Introduction

This is a series of volumes which deal with specific TV receiver troubles and their cures. These trouble cures are the TV manufacturers' answers to some of the problems that may arise in their particular receivers.

Fig. 63 — Philco

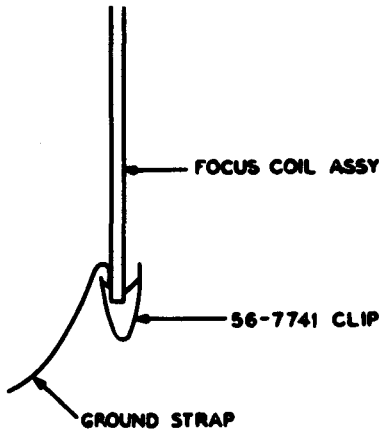
Reducing harmonic beat
(see Fig. 63).

Fig. 64 — Philco

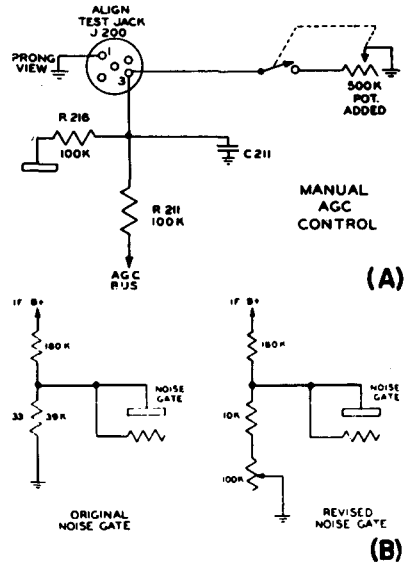
The variable control has an advantage over the regular Fringe-Normal kit 45-1732 in locations where signal level and noise conditions vary over relatively short periods of time.

Under conditions of heavy noise, as would be experienced in some fringe areas, it is advantageous to be able to manually control the bias on the noise-gate diode, thus controlling the clipping level of the tube. A circuit to accomplish this is shown in part (B) of the figure. The 39,000-ohm resistor is replaced by a 10,000-ohm resistor in series with a 100,000-ohm potentiometer.
